Addendum

Flooring Replacement
Shaw Building
3750-15074

ADDENDUM # 02 **November 16, 2015** **Page 1 of 1**

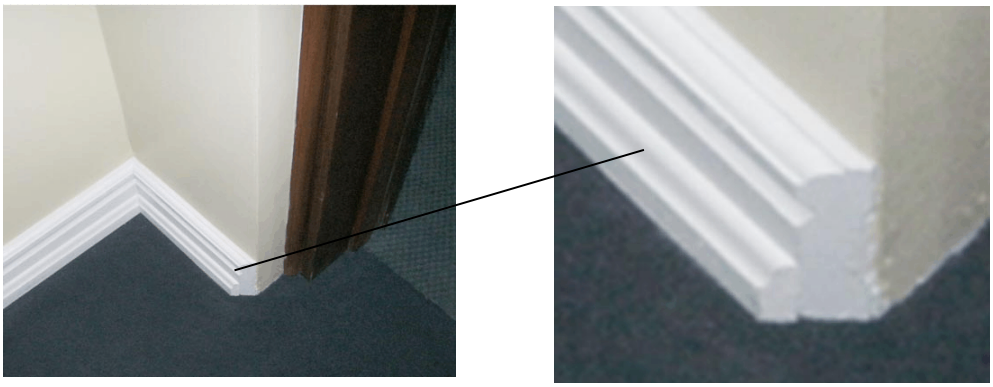
11. Existing wood base in Rooms 505, 506, 510, 512, 517 and 529: Remove existing secondary 1 ½" trim base before removing existing carpet. Replace with new trim to match existing; patch and paint to match existing.
